INDEPENDENT EXAMINATION OF THE FAIRFORD NEIGHBOURHOOD PLAN: JOINT RESPONSE TO THE EXAMINER'S CLARIFICATION QUESTIONS

On 21 December 2022, the Independent Examiner for the Fairford Neighbourhood Development Plan issued a number of clarification questions, directed to Fairford Town Council (FTC) and Cotswold District Council.

Appendix 1

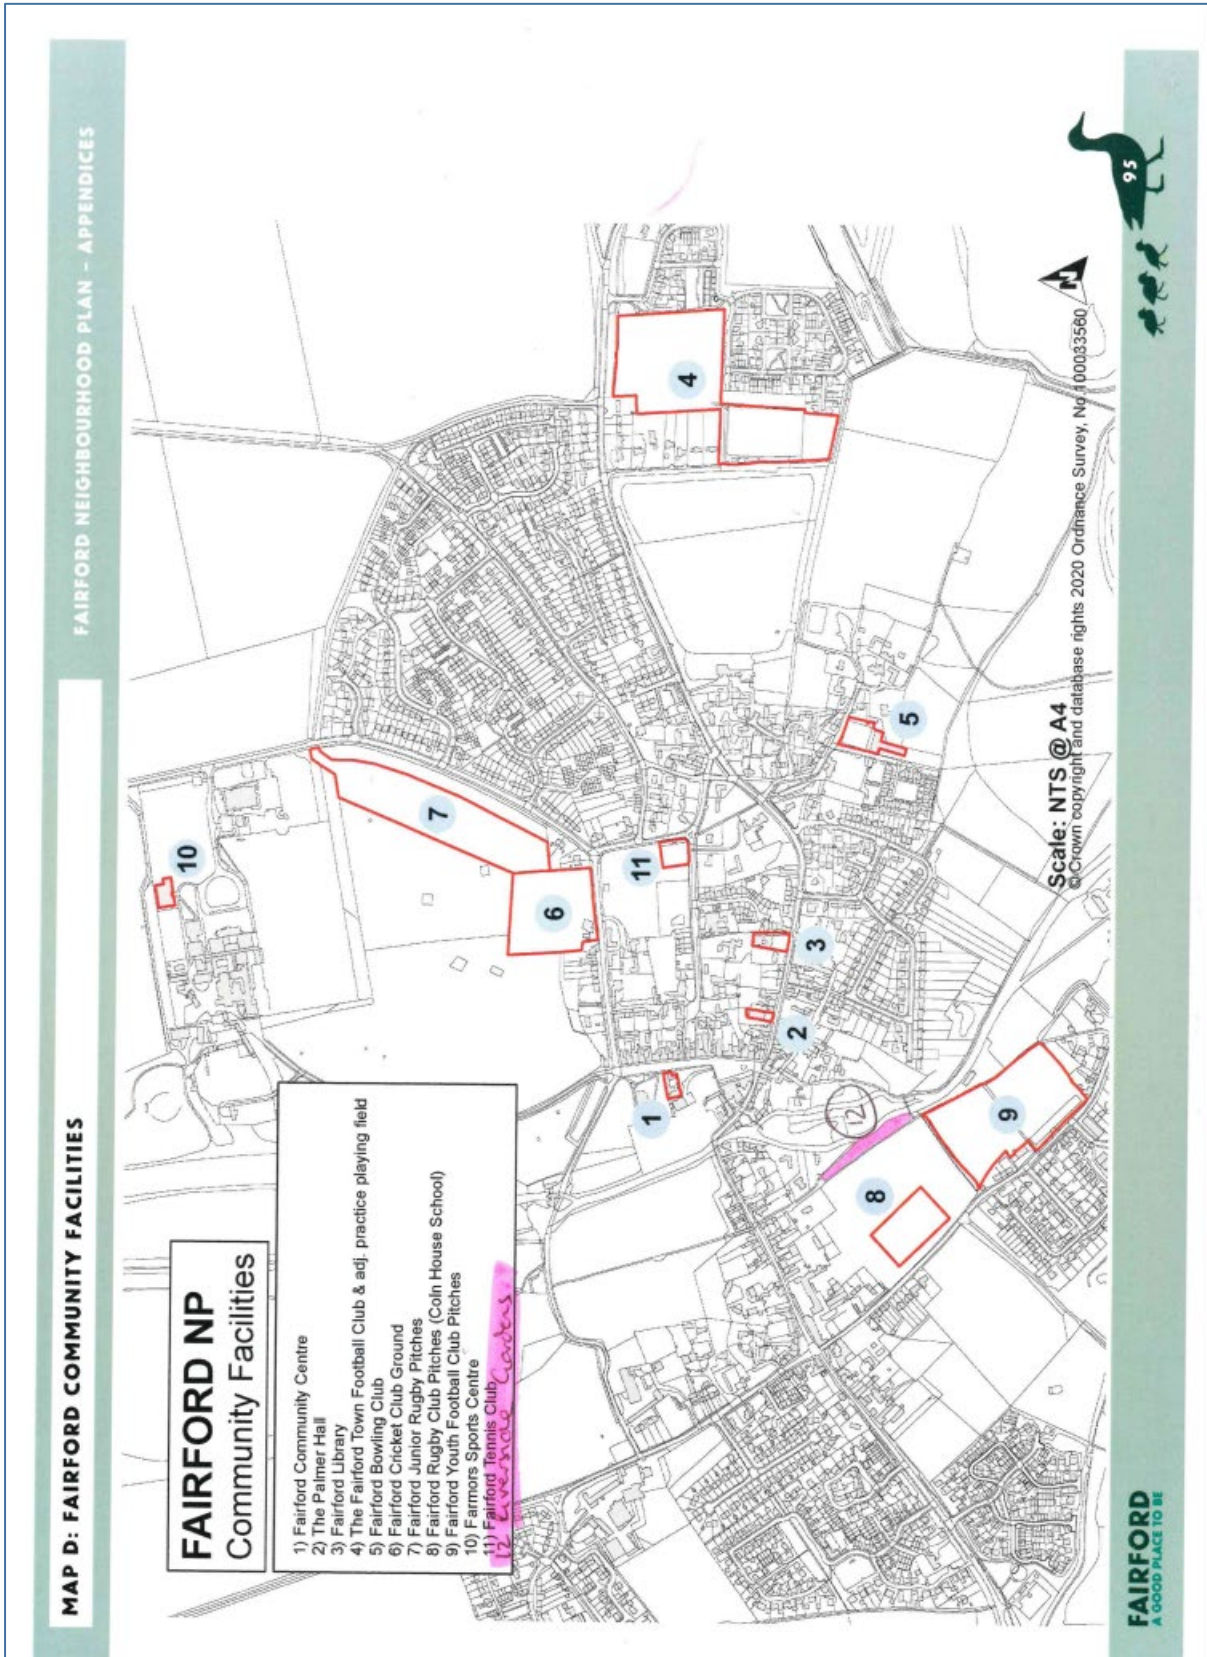
3. **Question to FTC.** Policy FNP3.1 I) Should Riverside Gardens be included on Map D: Community Facilities? If so, please show where?

This 'Riverside Garden' is public 'garden' area between the footpath running past the NE side of the Coln House playing field and the river. Please find appended to this response as appendix 1, a version of Map D with an annotation showing this location.
